ADDENDUM No. 1
AHWAHNEE MIDDLE SCHOOL WATER AND SEWER MAIN REPLACEMENT
Informal Bid No. 1010-35131

ADDENDUM No. 1 (Continued)
AHWAHNEE MIDDLE SCHOOL WATER AND SEWER MAIN REPLACEMENT
Informal Bid No. 1010-35131

<p>Ahwahnee Middle School Infrastructure Replacement</p>	Scale	None	SHEET:	P-1/REV 1
	DATE:	6/8/2020

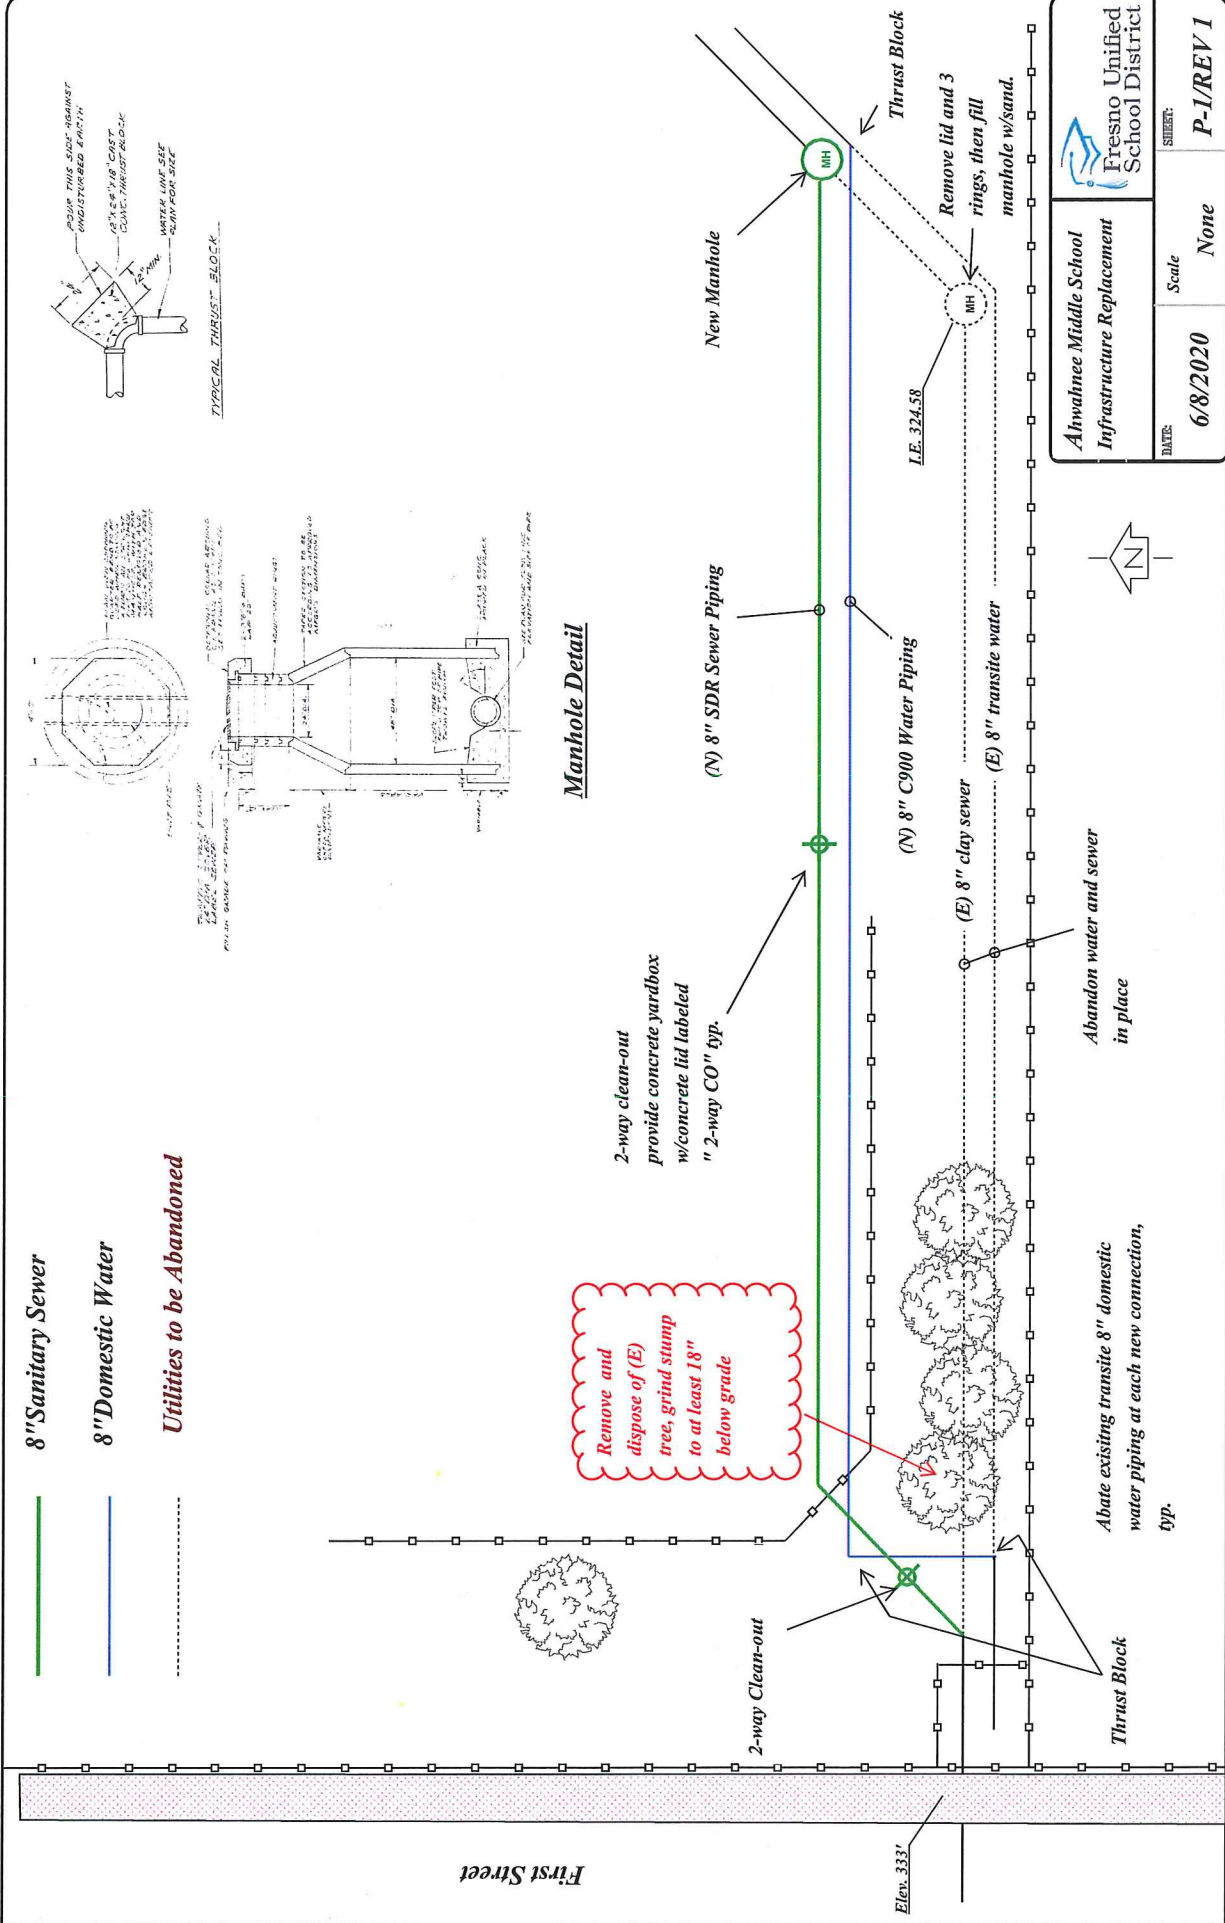
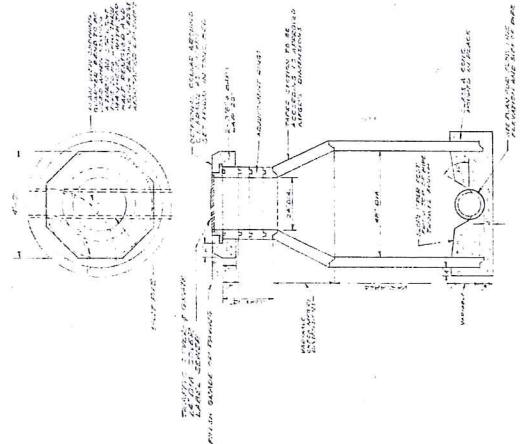
Bidders shall replace Plan sheet P-1 with P-1/REV1. Revisions includes tree removal and additional details.

Remove and dispose of (E) tree, grind stump to at least 18" below grade
